Access Compliance Report

Public Rights-of-Way (Curb Ramps)

Intersection ID: 10034399	Main Street: PIEDMONT_PARK_DR	Cross Street: AUDUBON_PARK_DR	Location: E
ADA ID: D1D6A186F586	Ramp Type: Directional1	Initial Pass/Fail: Pass	Overall Compliance: No
		Severity Score: 0

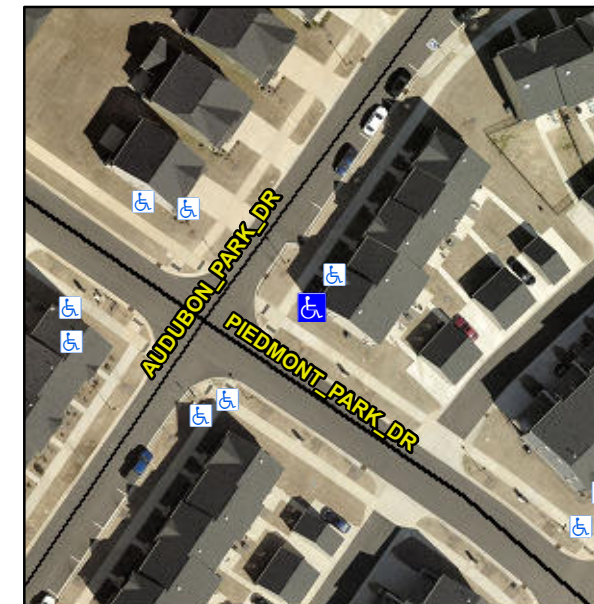
**Remove & Replace Detectable
Warning System.**

R305.2
